RENESAS TECHNICAL UPDATE

Product Category	MPU & MCU	Document No.	TN-16C-A196A/E	Rev.	1.00
Title	Errata to R32C/156 Group Hardware Manual		Information Category	Technical Notification	
Applicable Product	R32C/156 Group	Lot No.	Reference Document	R32C/156 Group Hardware Manual Rev. 1.03 (REJ09B0506-0103)

This document describes corrections to the R32C/156 Group Hardware Manual, Rev. 1.03.
The corrections are indicated in red in the list below.

Figure 24.33 LIN Low Detection Interrupt Block Diagram

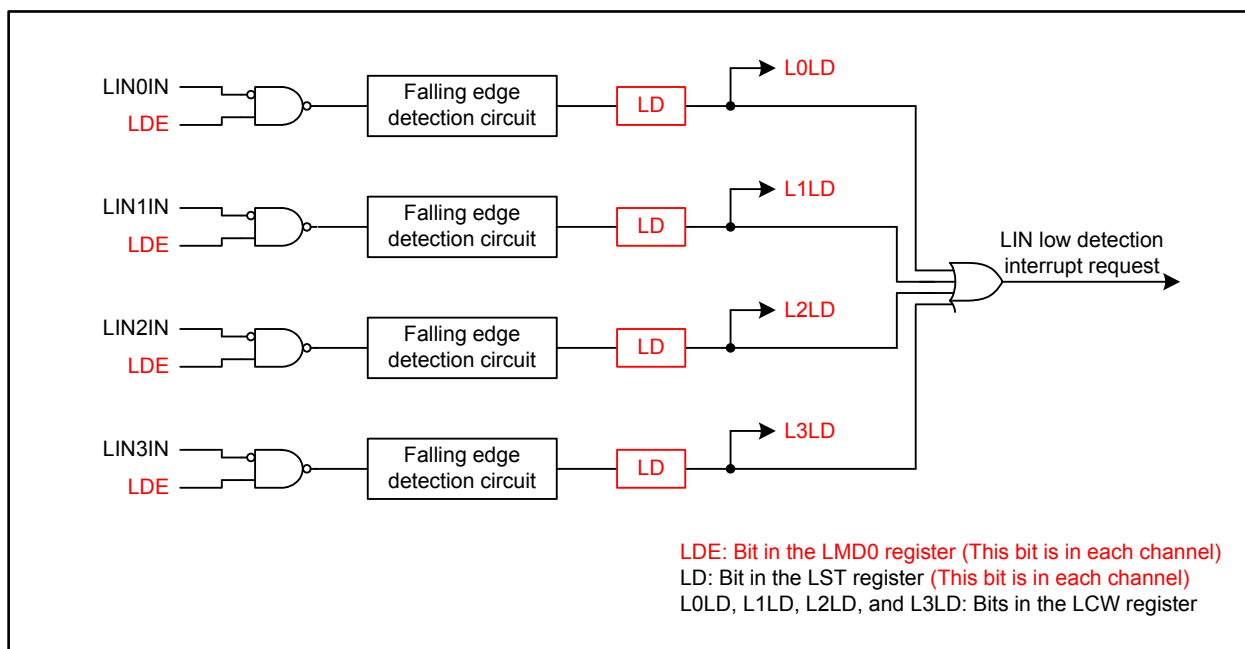
- Page 423 of 621, Figure 24.33 is corrected as follows:

Figure 26.1 Typical I/O Pin Block Diagram (i = 0 to 15; j = 0 to 7)

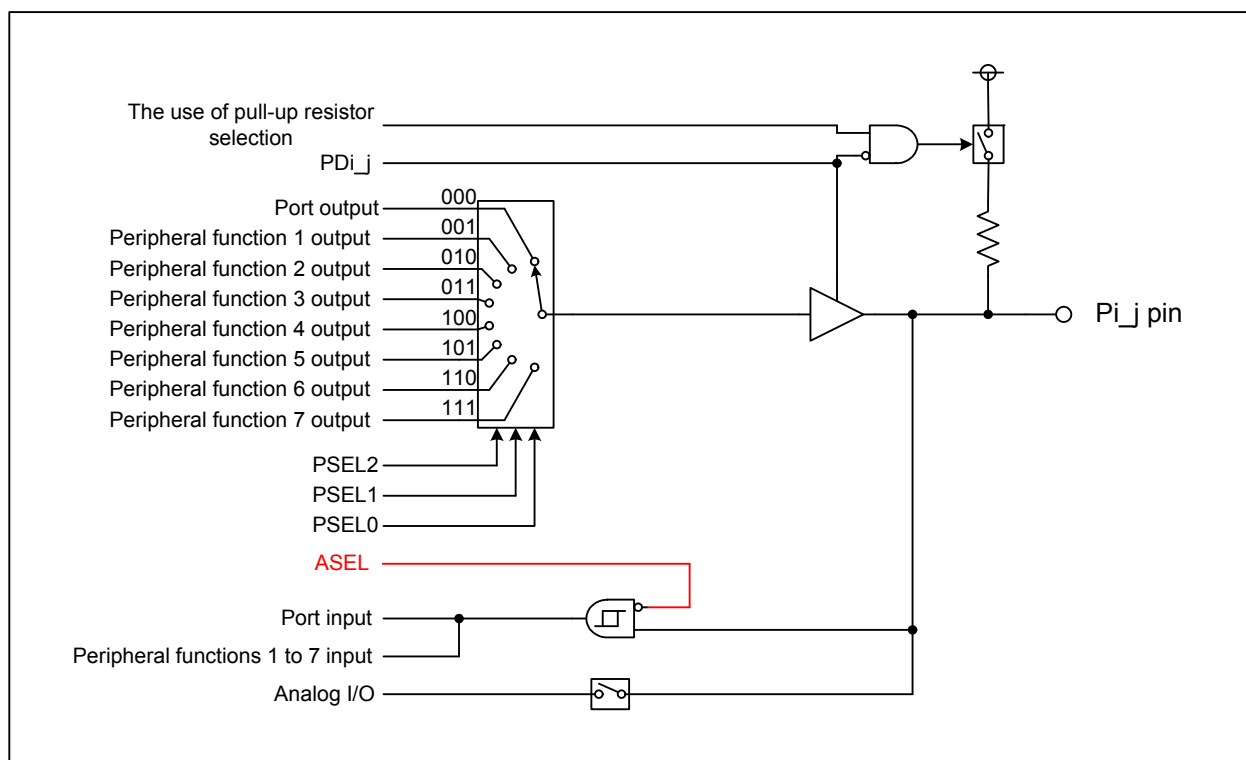
- Page 493 of 621, Figure 26.1 is corrected as follows:

Figure 27.2 Addresses for ID Code Stored

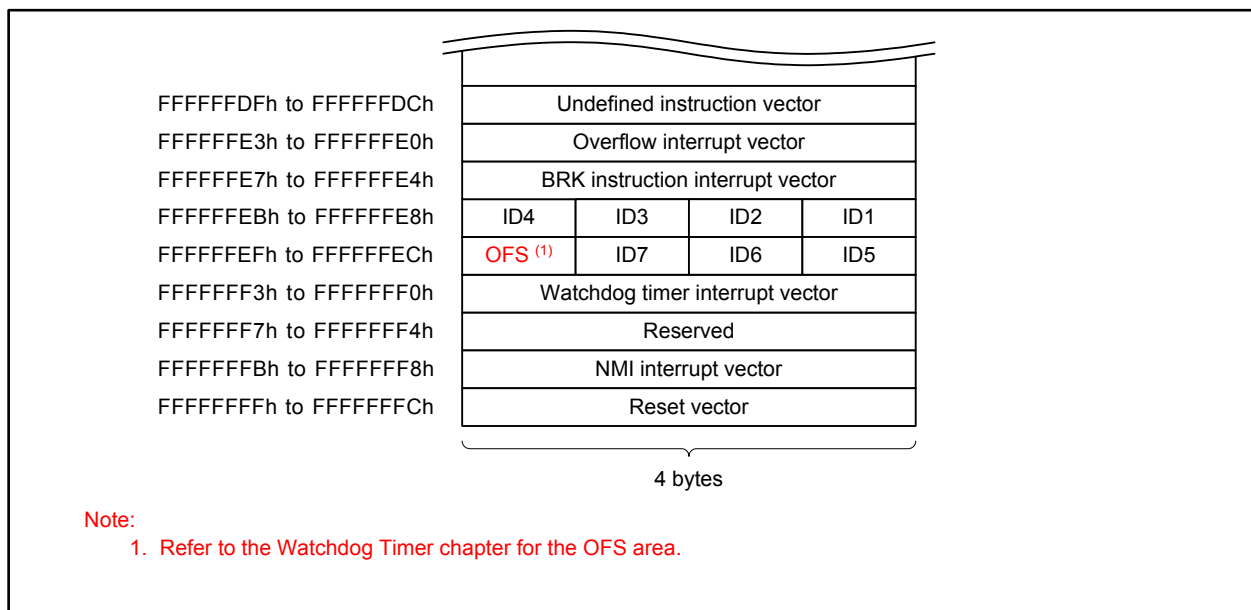
•Page 527 of 621, Figure 27.2 is corrected as follows:

Figure 27.12 Read Timing

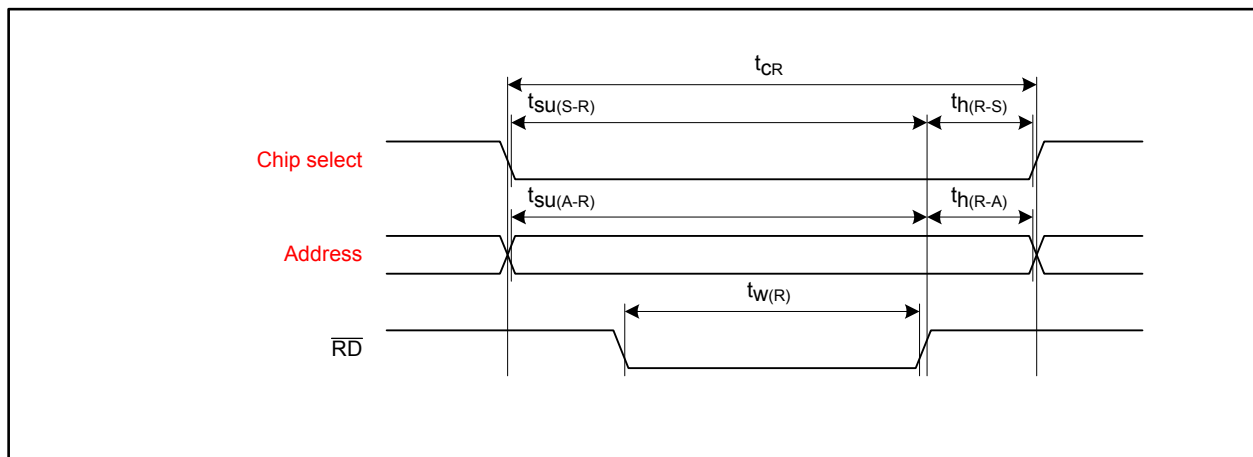
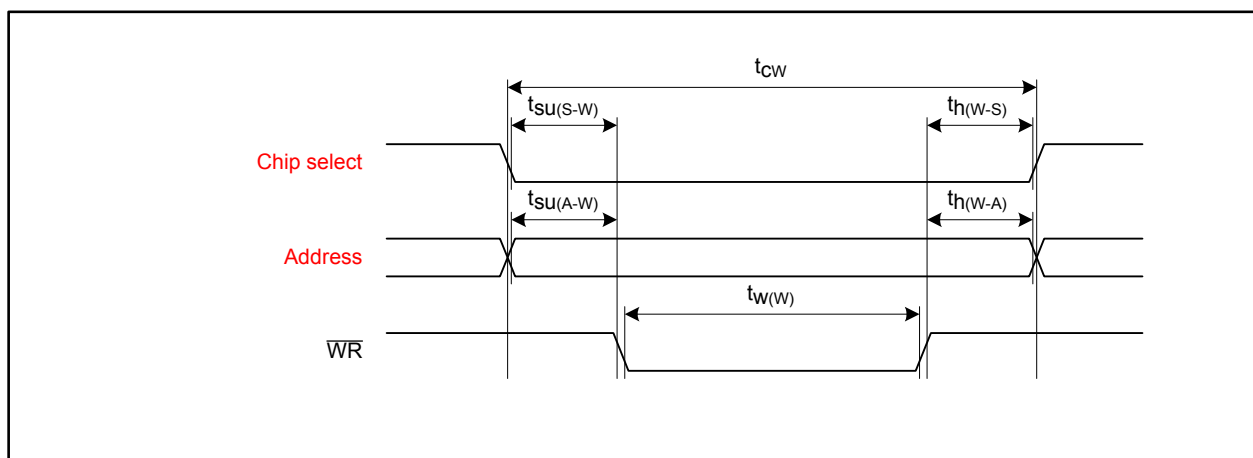
•Pages 535 and 537 of 621, descriptions in Figures 27.12 and 27.13 are corrected as follows:

Figure 29.5 Flash Memory CPU Rewrite Mode Timing

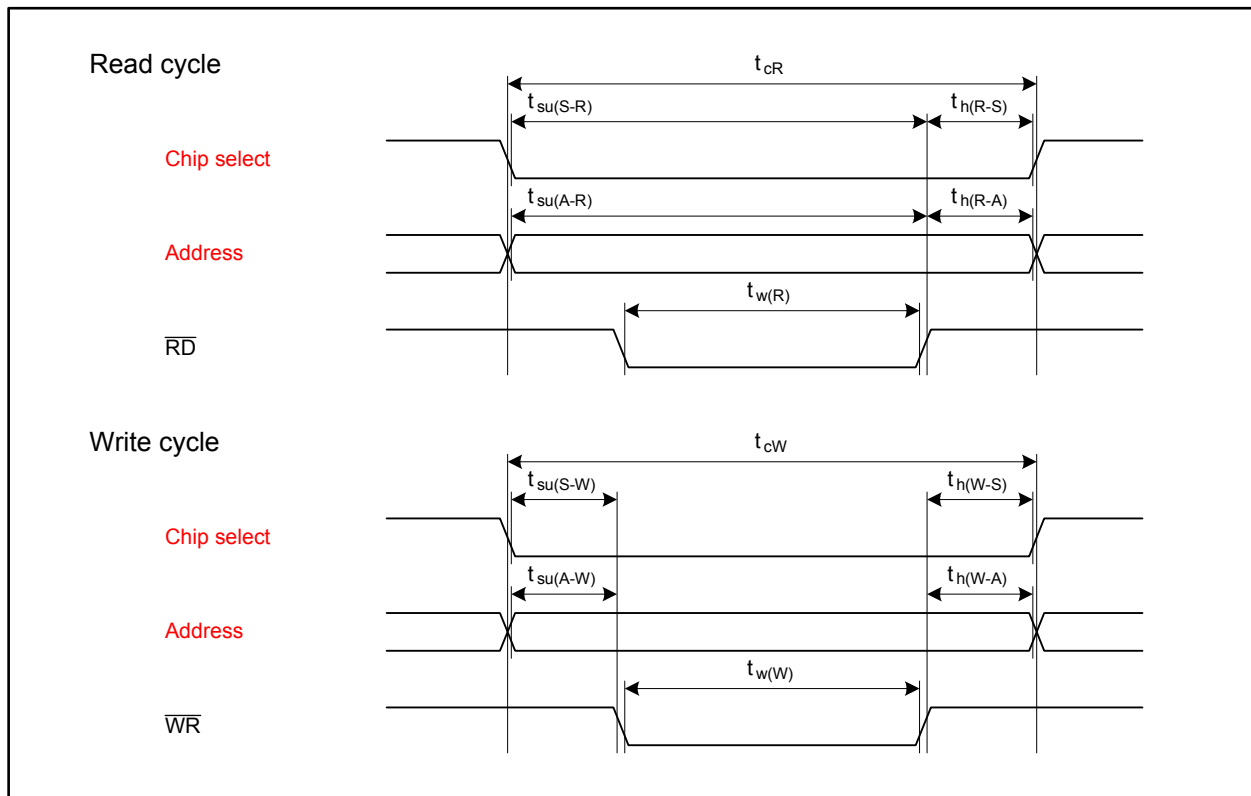
- Page 555 of 621, description of Note 3 in Figure 28.2 is corrected as follows:
 “When this bit is set to 1, the module stops ongoing operations to enter its initial state. However, the registers are not initialized.”
- Page 555 of 621, description “This mode setting prevents data from being overwritten if a program goes out of control.” is deleted from Note 5 of Figure 28.2.
- Page 557 of 621, figure title “F2FI Register” for Figure 28.7 is corrected as follows:
 “E2FI Register”
- Page 561 of 621, description for EERR bit setting in Figure 28.12 is corrected as follows:
 “EERR bit in the E2FS0 register is 0?”
- Page 574 of 621, descriptions in Figure 29.5 are corrected as follows:
